UNITED STATES PATENT AND TRADEMARK OFFICE

APPLICATION NO.	FILING DATE	FIRST NAMED INVENTOR	ATTORNEY DOCKET NO.	CONFIRMATION NO.
10/638,849	08/11/2003	James Xixian Wu	SP-1076.2 US	4449
20875	7590	02/17/2006	EXAMINER	
MICHAEL C. POPHAL EVEREADY BATTERY COMPANY INC 25225 DETROIT ROAD P O BOX 450777 WESTLAKE, OH 44145			CANTELMO, GREGG	
			ART UNIT	PAPER NUMBER
			1745	
DATE MAILED: 02/17/2006

Office Action Summary

DETAILED ACTION

FIG. 1 OF THE INSTANT APPLICATION

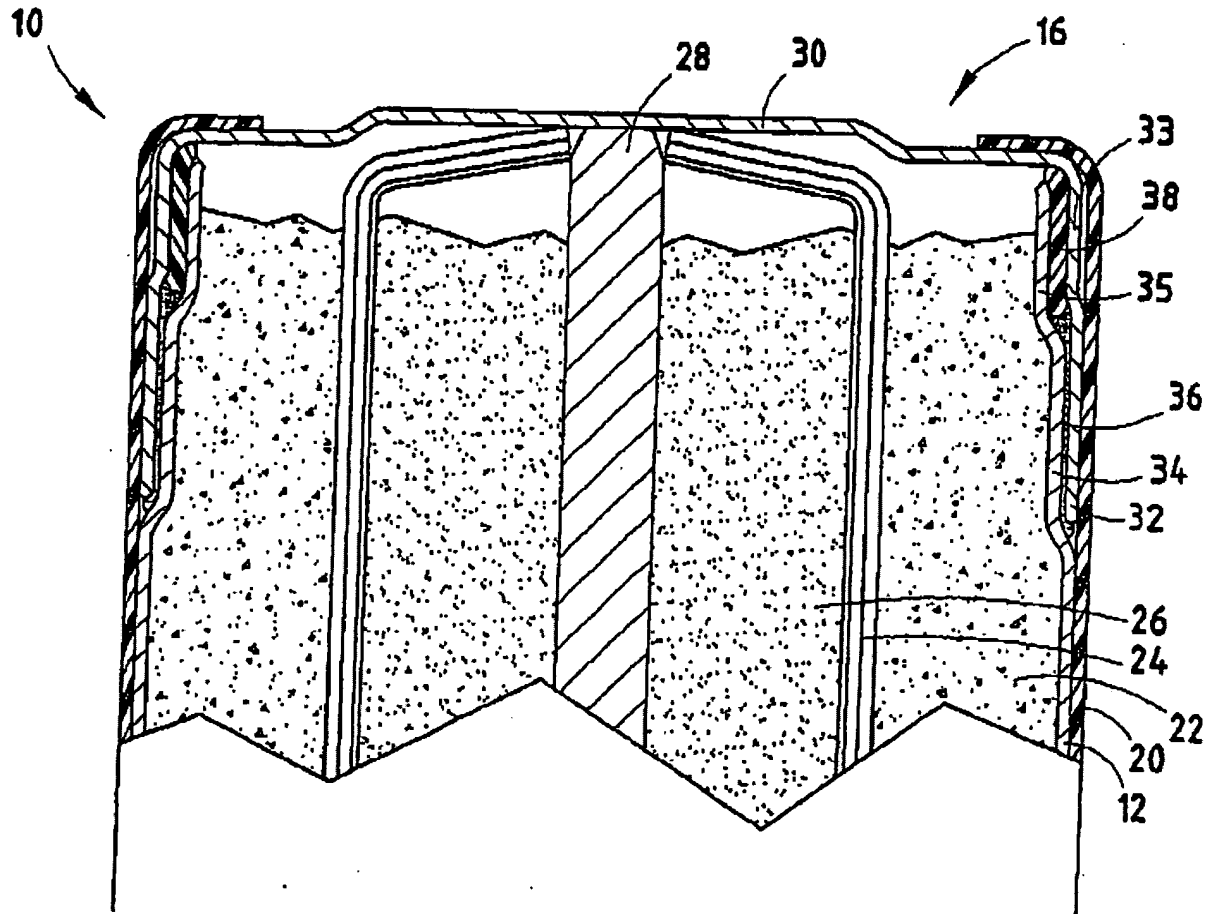
Applicant's own disclosure of to Fig. 1 shows that the cover 30 which is cup-shaped having bent edges is placed in a sealing arrangement with the container. The disclosure of Riedl is identical to this arrangement as claimed (discussed above). A complete review of the original disclosure of the instant application reveals that Applicant's own disclosure recognizes this arrangement to be exemplary of a non-crimped design (see Fig. 1 and paragraph bridging pages 6 and 7 of the instant Applications own disclosure).

Provided herein is a side-by-side comparison between Fig. 1 of the instant application, an admitted embodiment of a non-crimped arrangement between the cover and container of a battery and Fig. 3 of Riedl.

In Fig. 1 of the instant application, reference character 30 corresponds to the cover and 12 to the container. As described in the paragraph bridging pages 6 and 7 of

the instant application, this arrangement is a non-crimped arrangement between the cover 30 and container 12.

FIG. 3 of RIEDL

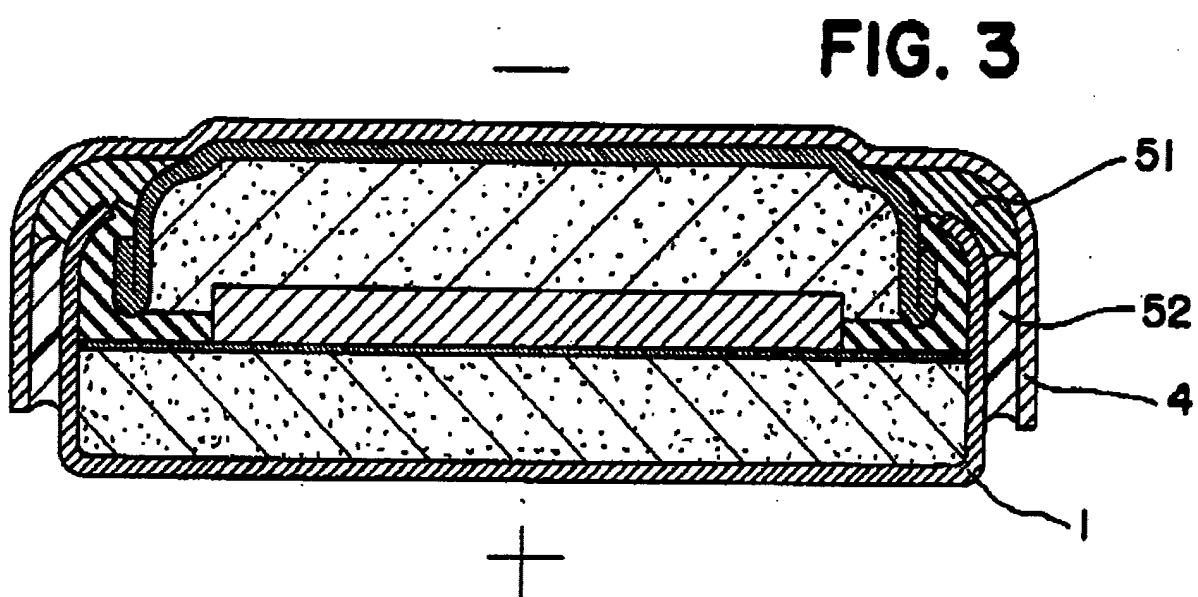
First adhesive 51 is closer to the open end of the container 1 and the second adhesive 52 is located further away from the open end of the container (Fig. 3 as applied to claim 4).

The cover 4 has a peripheral wall which extends outside the side wall of the container 1 and at least some of the first and second sealing materials 51 and 52 are disposed between the side wall of the container and peripheral wall of the cover (Fig. 3 as applied to claim 19).

In Fig. 3 of Riedl, reference character 4 corresponds to the cover and 1 to the container. This arrangement, structurally identical to the cover and container arrangement with respect to the claimed invention is also understood to be non-crimped arrangement between the cover 4 and container 1.

It should be apparent for the reasons set forth above, and from the analysis of the corresponding figures below, that the prior art in fact anticipates the non-crimped structure. Therefore the rejection stands.
